STAFF REPORT
KETCHUM PLANNING AND ZONING COMMISSION
MEETING OF SEPTEMBER 10, 2024

PROJECT: Residences at 691 N 1st Ave

FILE NUMBER: P24-069

APPLICATION: Pre-Application Design Review

Figure 4. Roof overhangs exacerbating bulk of building

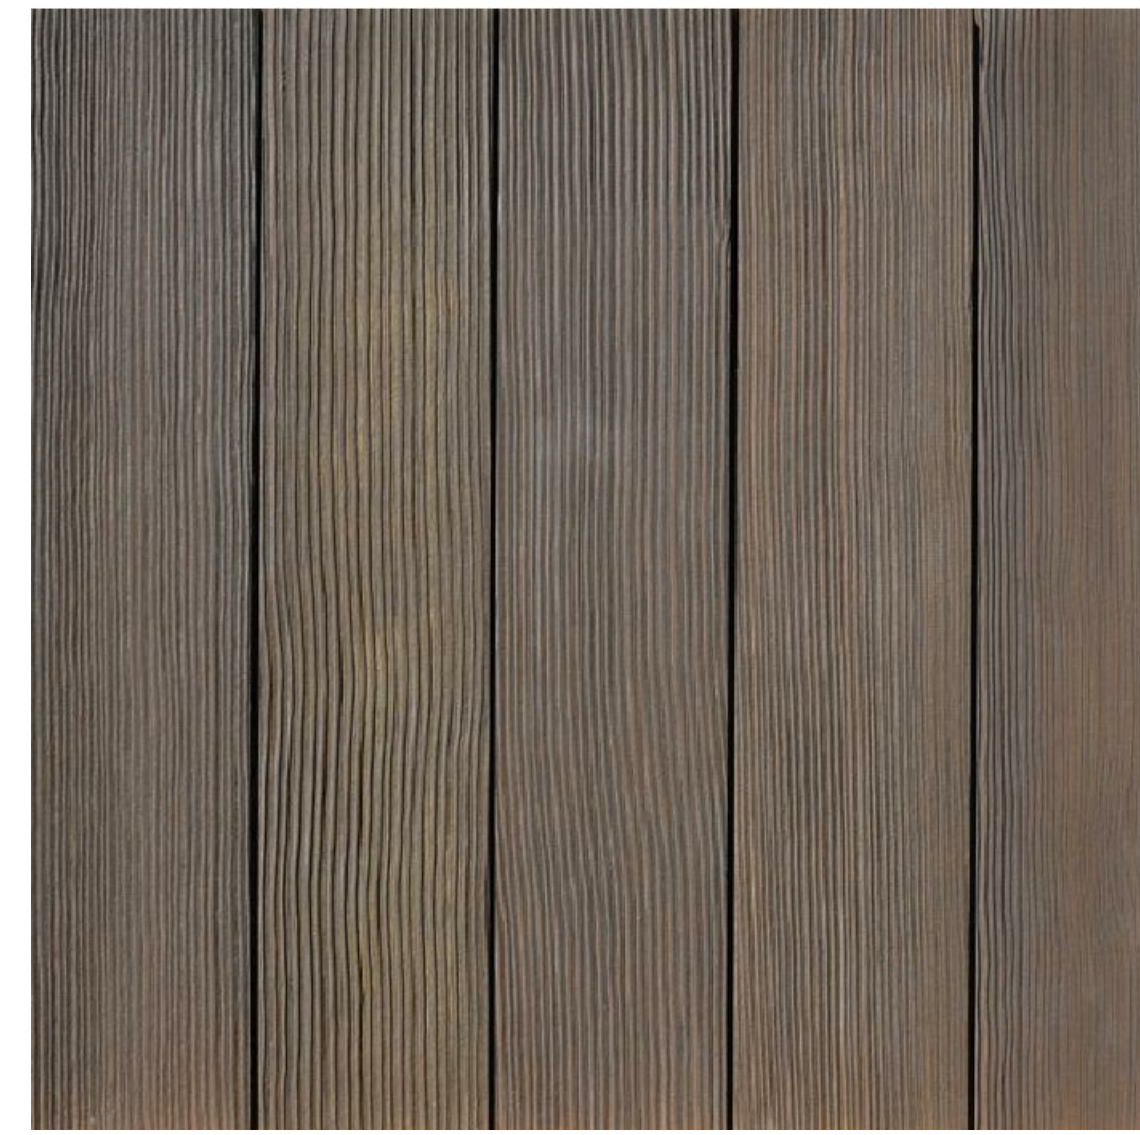
Pursuant to KMC §17.96.060.F.5, building walls shall provide undulation and relief to reduce the appearance of bulk and flatness. The proposed design includes projections of building mass on the second and third floors. Staff finds these projections make the building appear top heavy,

particularly with the cantilevered decks on the alley corner and north corner of the building (See Figure 4). While the facades at the corner decks are recessed, they don't effectively reduce the apparent mass of the building due to the deck/roof overhangs above them.

1 ARCHITECTURAL SECOND FLOOR PLAN
 A2.2 SCALE: 3/16" = 1'-0"

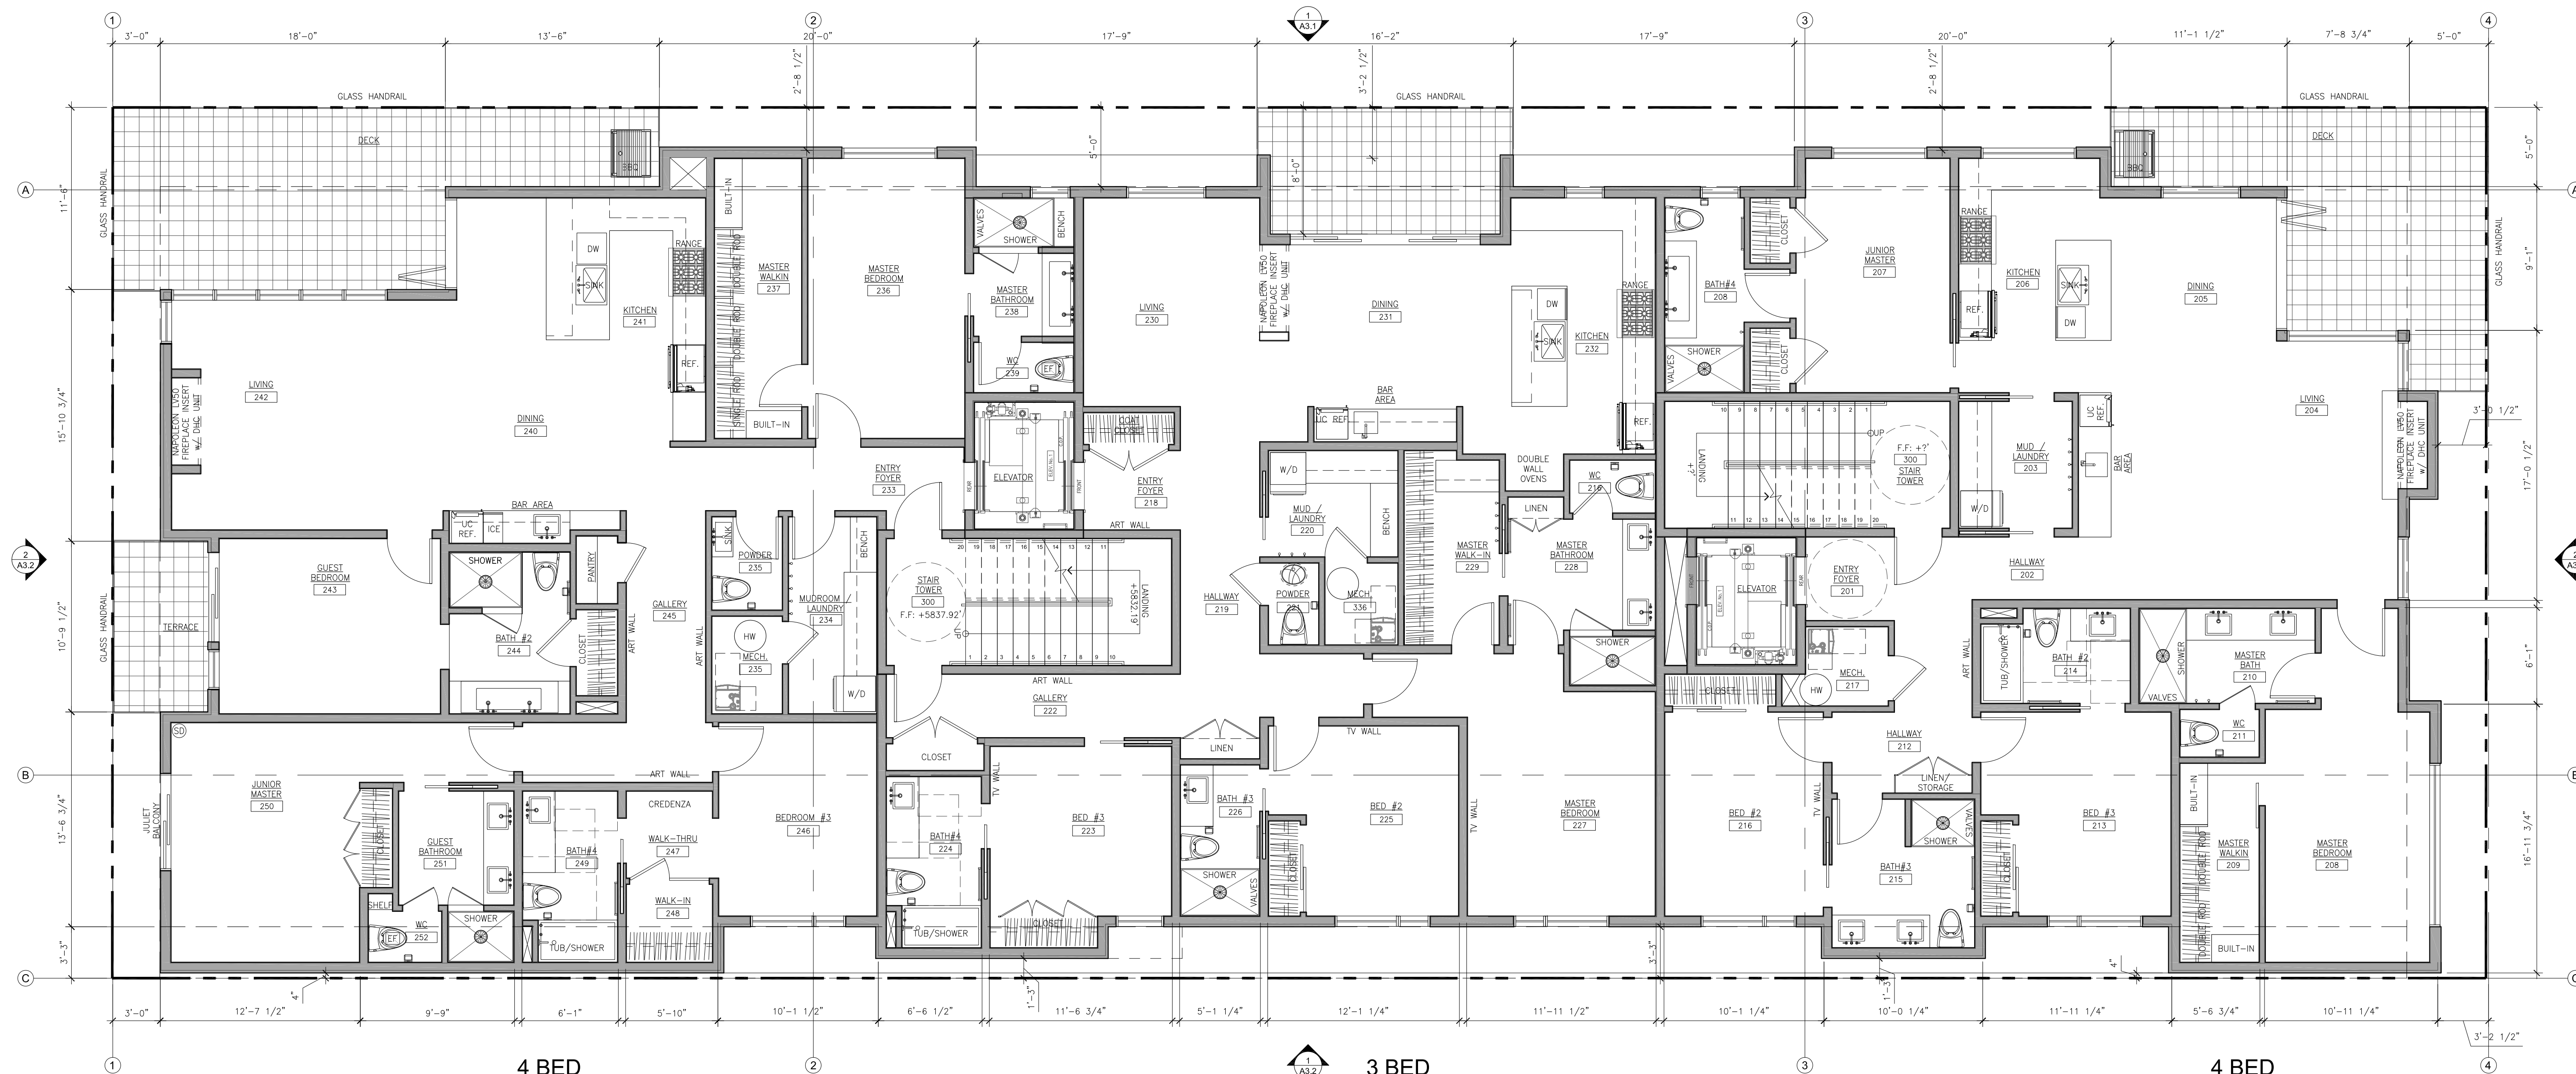
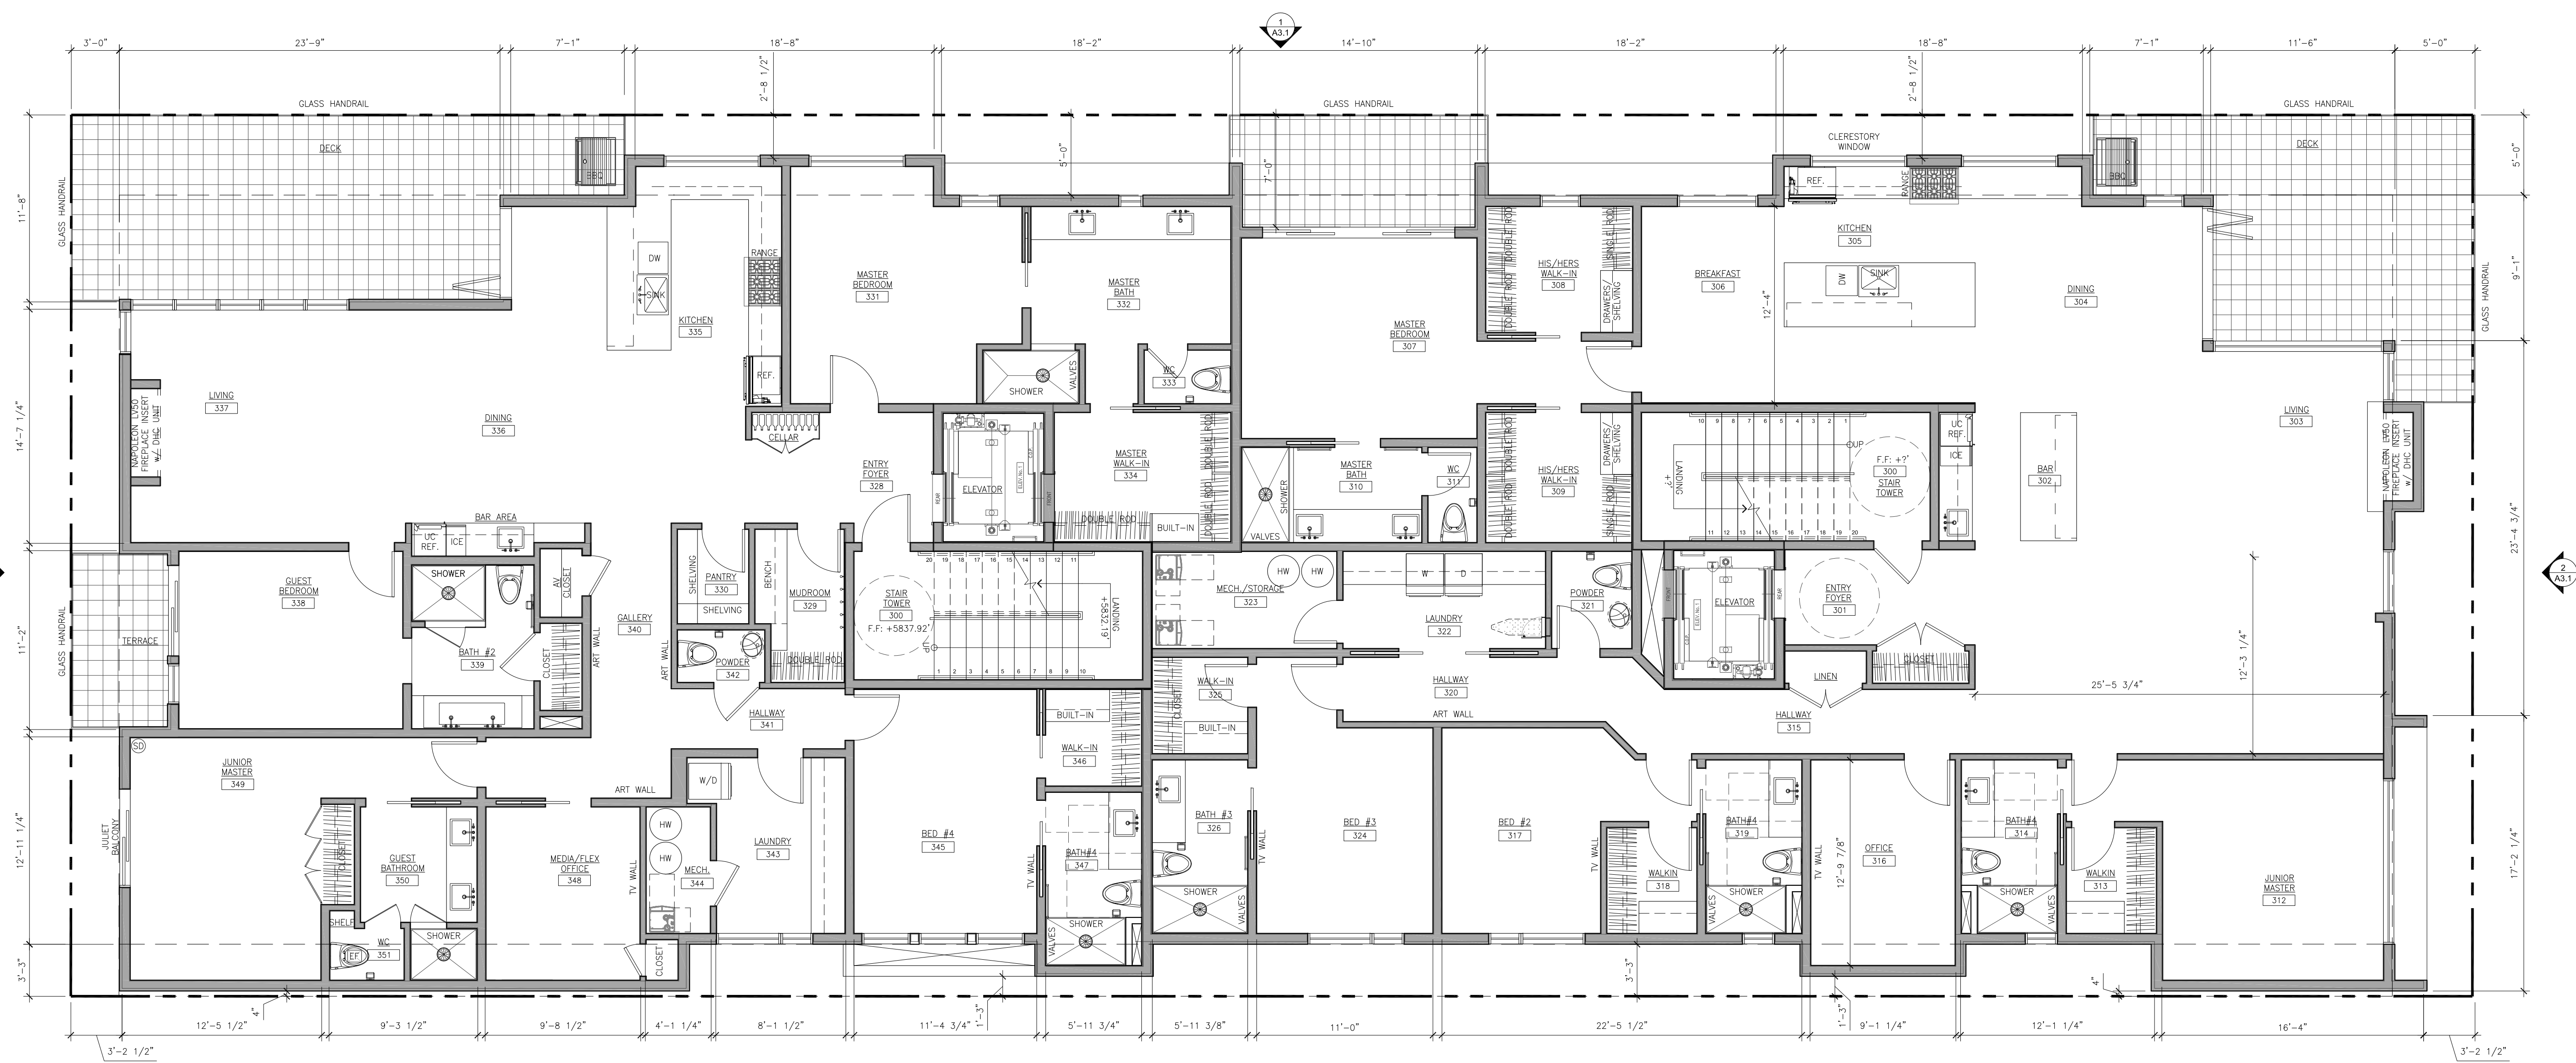
3. The windows shown on the south side of the 2nd and 3rd floor plans do not match the elevations or the 3D model. As a neighbor I would like to know how the window placement affects my property.

2 WEST EXTERIOR BUILDING ELEVATION
 A3.2 SCALE: 3/16" = 1'-0"

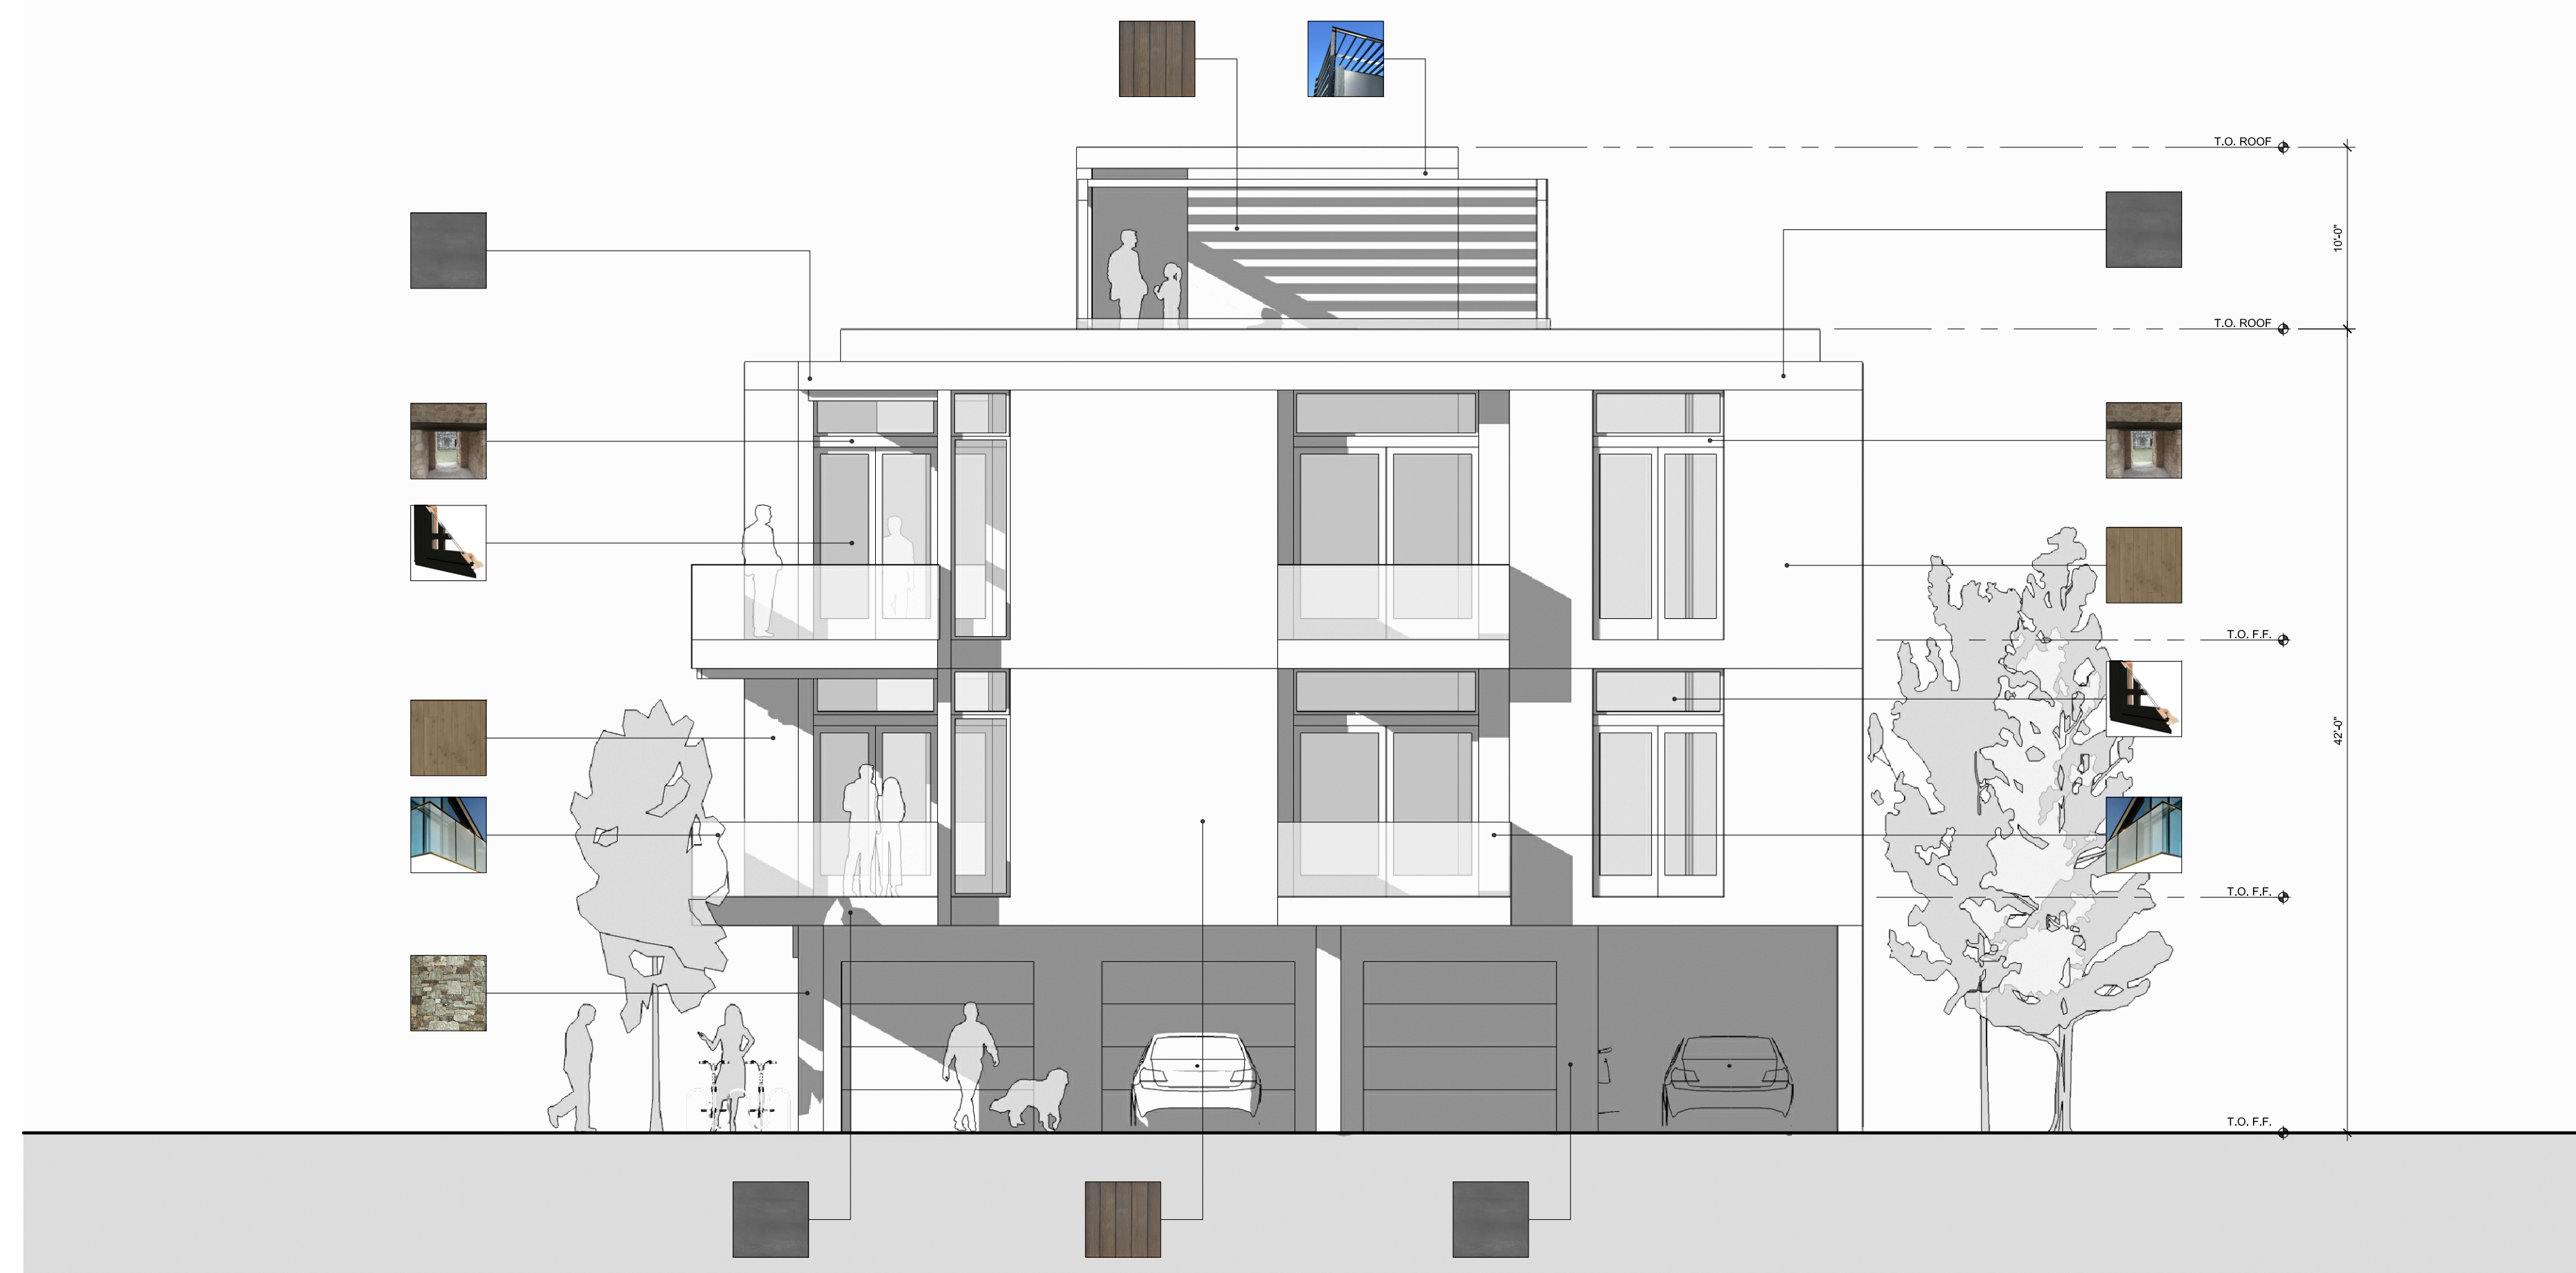
1. The height of the building on the elevations seems to be incorrect. The height is shown as 42' to the top of the 3rd floor, not including the roof level mechanical space and terraces. Please have applicant verify.

2. The submitted plans show the building to be on a flat lot. The lot slopes. Please have the applicant specify the height of the building as defined in the Ketchum Code *17.08 Definitions: Height of Building/CC District*

7. The wall openings on the south side must meet IBC Table 705.8. Windows in walls that are 3' to less than 5' from the property line can only be 15% of the wall area that is 3'-5' from the property line counted on a floor-by-floor basis. The elevations and 3d Model show a greater percentage.
